Ancoats Mobility Hub

Ancoats Mobility Hub
Design and Access Statement Addendum
February 2023

This addendum document to the Design and Access Statement has been prepared by Buttress in conjunction with the professional team (listed to the right) to support a Minor Material Amendment application for the mixed use development known as the Mobility Hub.

The proposed development was granted planning approval on 30th July 2021 (Reference: 130627/FO/2021). Since this time Manchester City Council have appointed Bowmer and Kirkland as main contractor to deliver the scheme. The proposed amendments within this application have been developed in response to initial market testing on the delivery hub operator and construction supply chain, and initial building control advice.

4.2 Green Wall Strategy

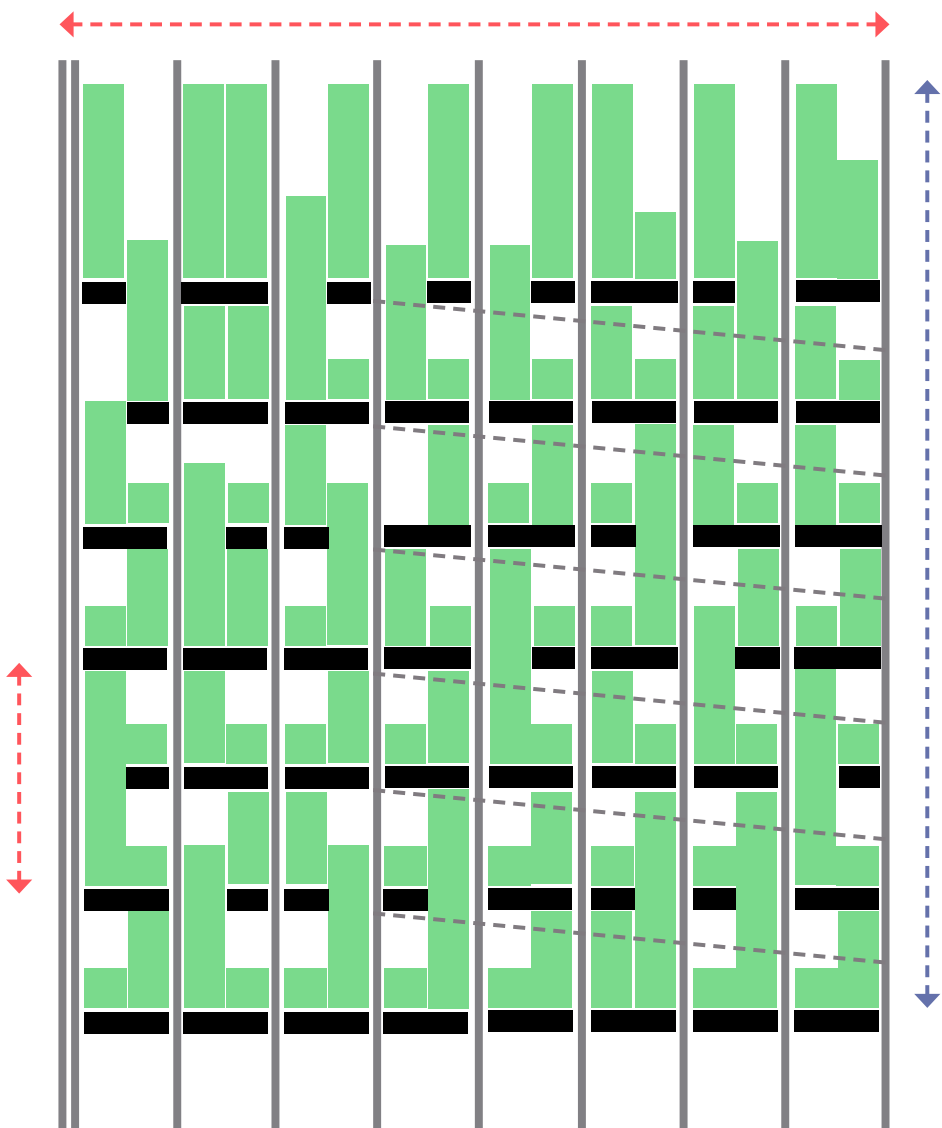
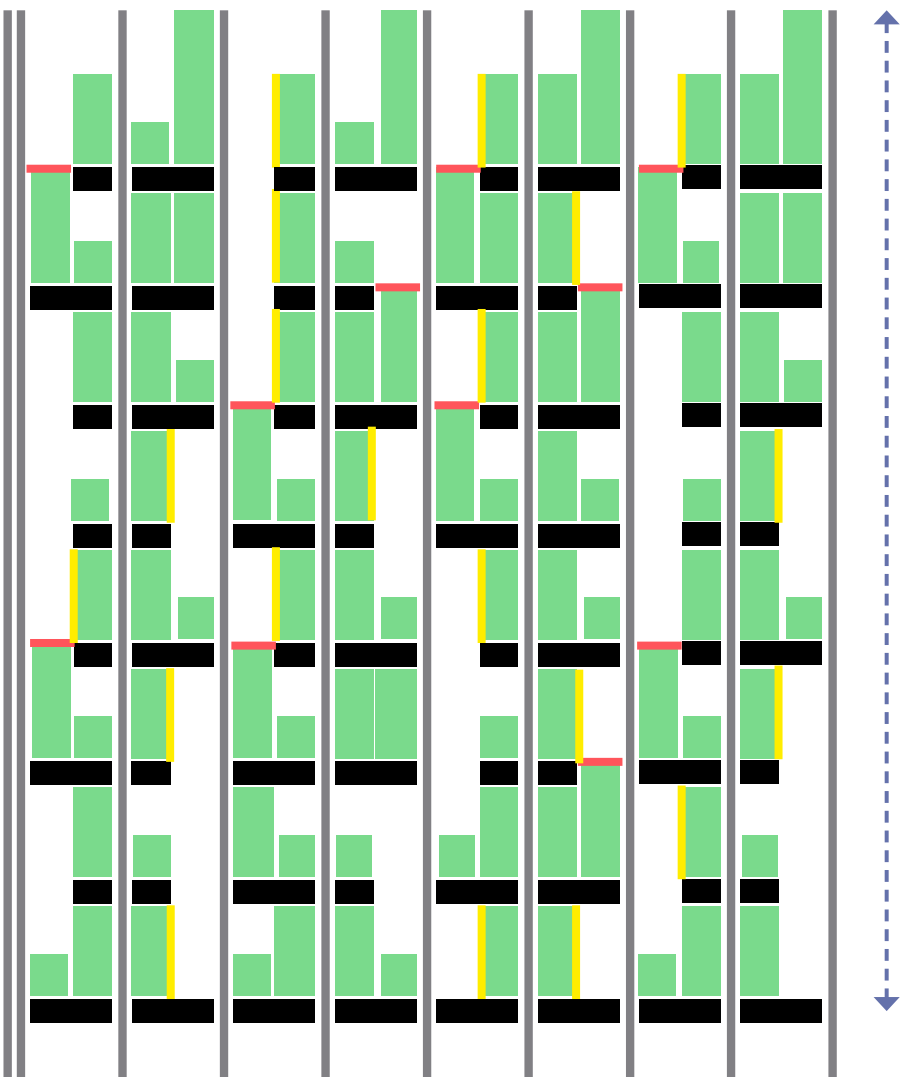
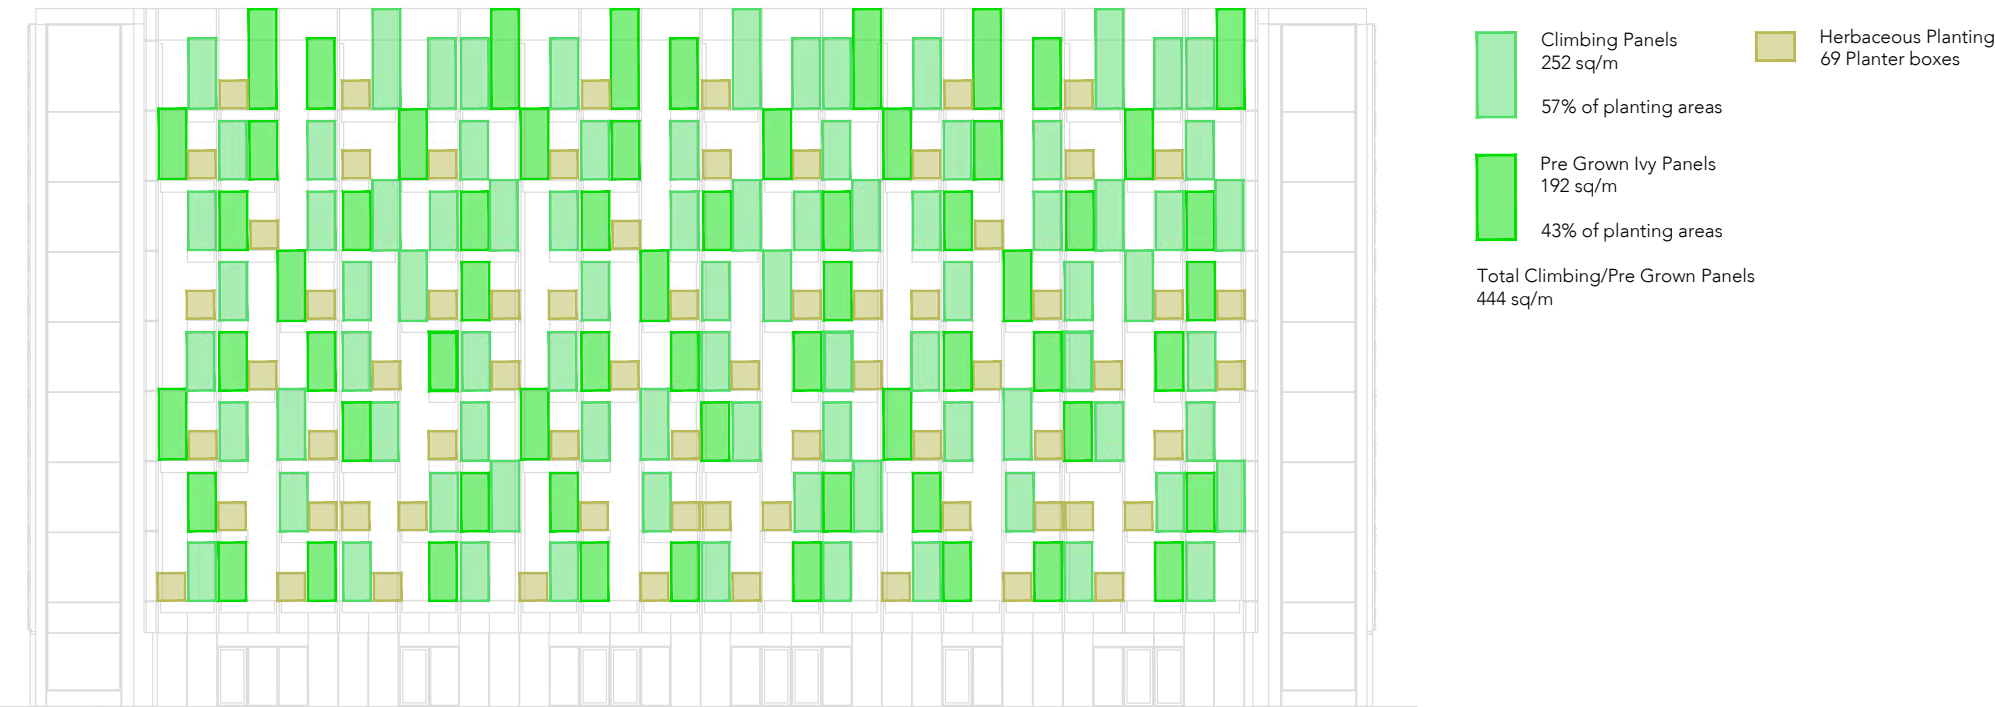
Following the planning approval a building control application was submitted and concerns were raised over the inclusion of green walls to the South facade in relation to the fire strategy.

The concerns raised were as follows:

- Planting spanning horizontally across the elevation with limited breaks.
- Planting spanning vertically across two levels.
- Sloped decks resulting in even single height panels spanning between floor levels.

The proposed amendments were as follows:

- Introduction of breaks in the planting every 5m.
- Planting areas contained to single height panels.
- Planter breaks provided by either planter boxes or horizontal panels at floor level.
- Flat deck structural solution creates consistent breaks at floor levels.
- Incorporation of vertical fins adjacent to planting gaps to contain planting within zones.
- Planting species to be selected to reduce maintenance and minimise the spread of flame.
- Increase the overall height of the planting to minimise planting loss.

4.4 South Elevation Amendments

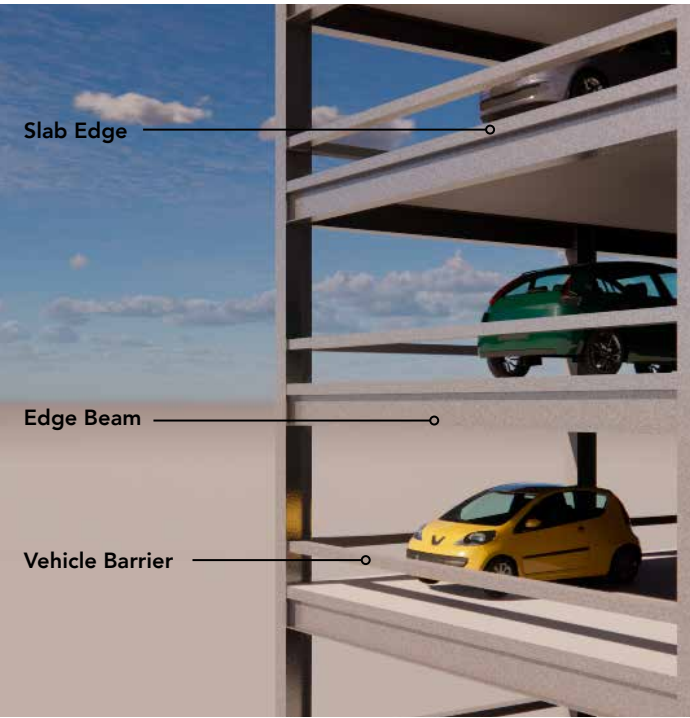
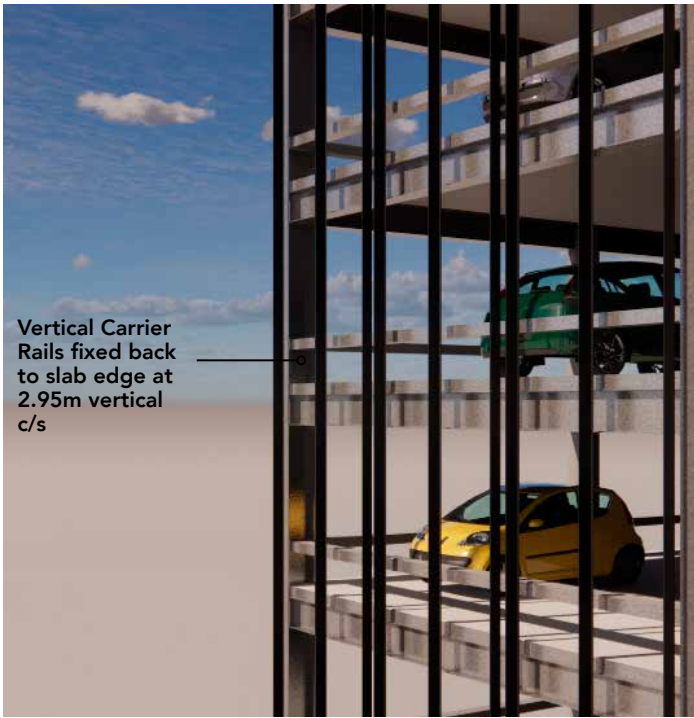
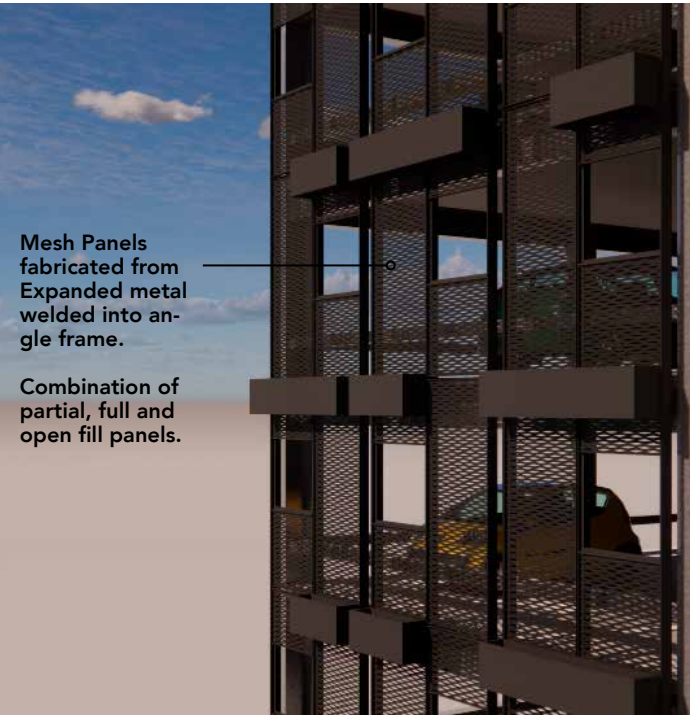
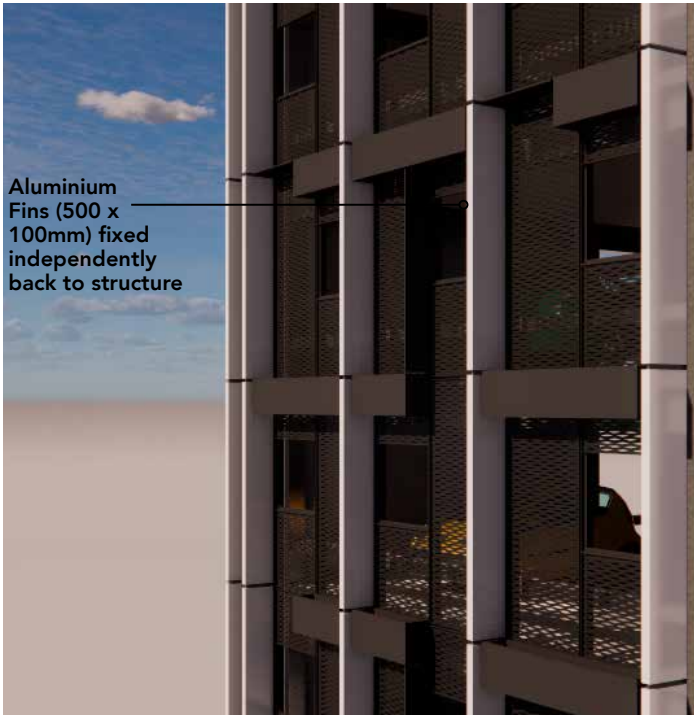
Further to the fire strategy concerns the updated facade design also included some design efficiencies to simplify the construction methods. These are as follows:

- Fin size reduced to 500mm deep x 100mm width.
- Planter box size reduced to 350mm deep.
- Spatial relationship between fin and planter box reduced by 50mm.

The structural steel frame will now be galvanised with the visual impact of the frame reduced as there is no requirement for perimeter bracing. The rails, vertical and horizontal breaks and mesh screening will all be PPC dark grey / black to ensure these elements are visually recessed and read separately from the aluminium fins and planting.

4.5 North Elevation Amendments

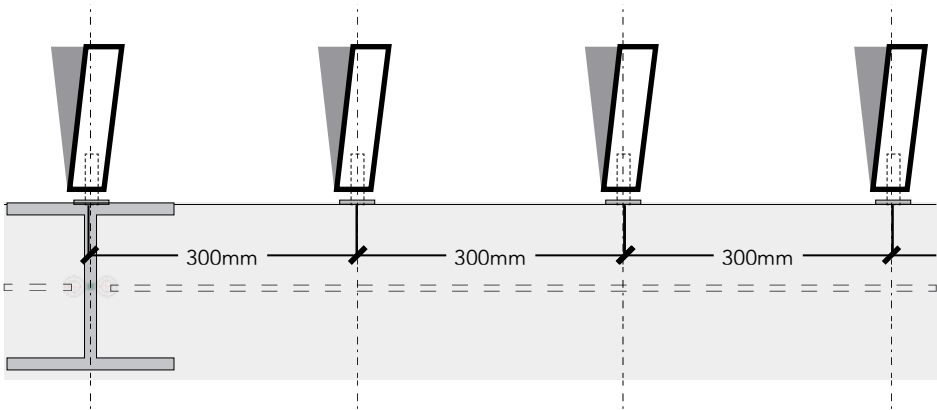
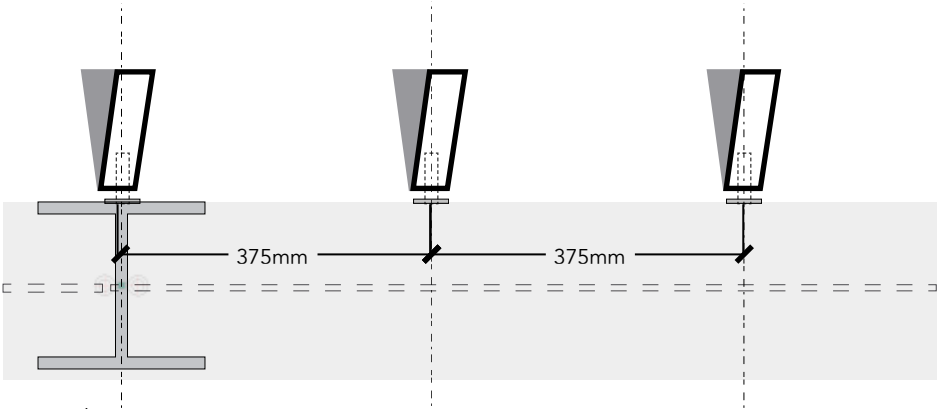
- Fin size reduced to 200mm x 50mm.
- Fin spacing increased to 375mm.

4.6 East/West Elevation Amendments

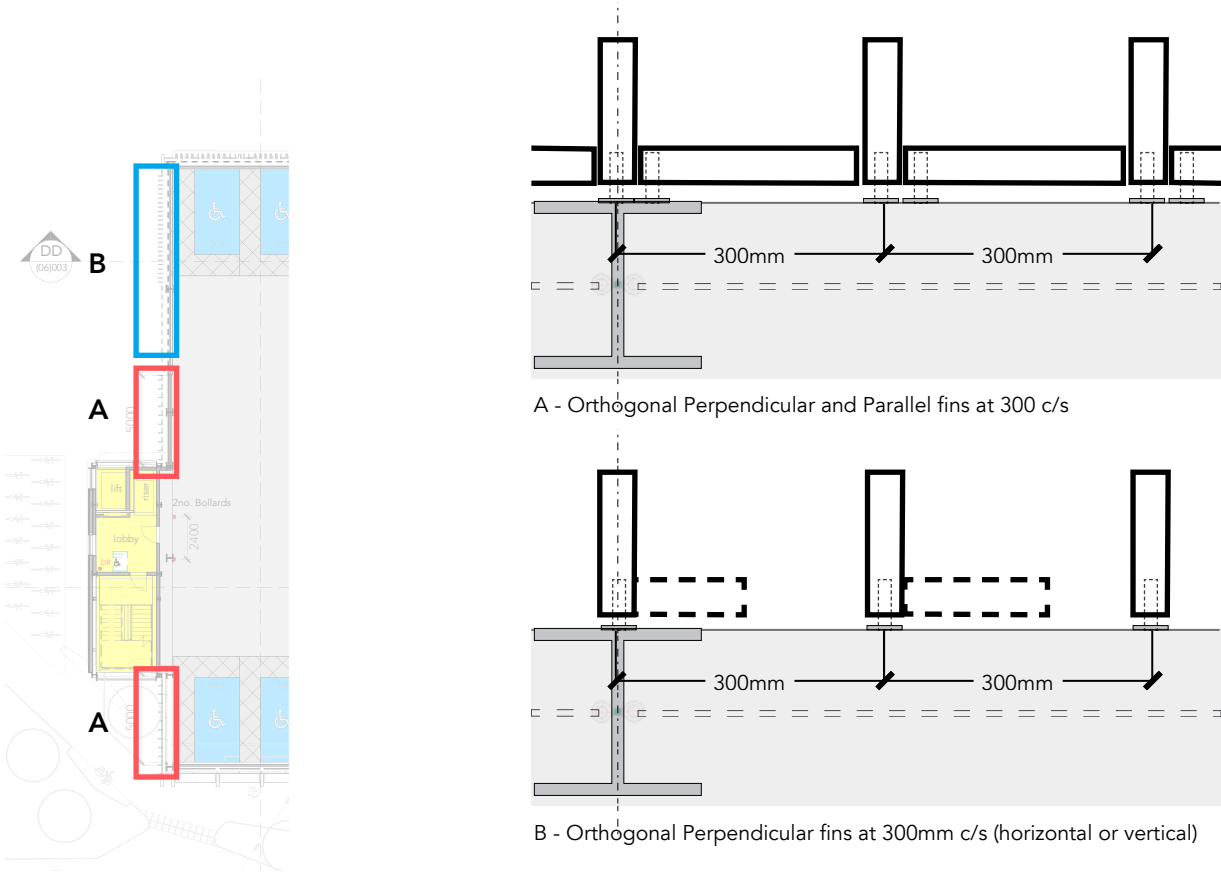
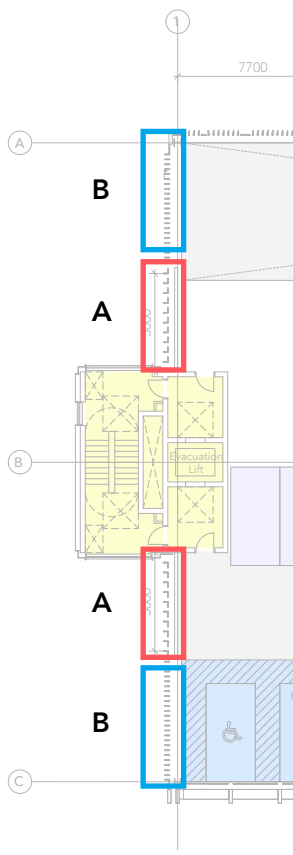
- Fin size reduced to 200mm x 50mm.
- Fin spacing increased to 400mm.
- Design principles retained to Fin Design A.
- Fin Design B refined to one design solution mirrored either side of the core.
